Office Action Summary	Application No. 10/566,794	Applicant(s) HUSTAD, JOHAN EINAR	
	Examiner DANIEL A. BERNSTEIN	Art Unit 3743

DETAILED ACTION

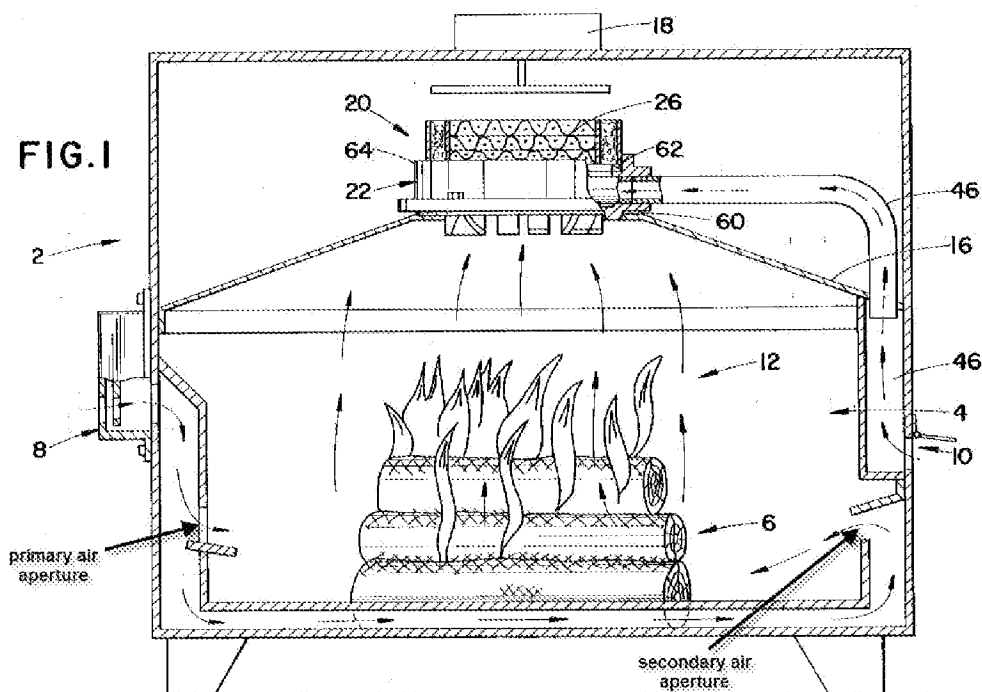
Barnett teaches a combustion chamber that as at least one secondary air aperture (secondary air aperture, see annotated Fig. 1 below) providing communication between ambient air (ambient air enters at 8 and is introduced through the secondary air aperture of Barnett substantially towards the bottom of the chamber) and the chamber near the bottom of said chamber.
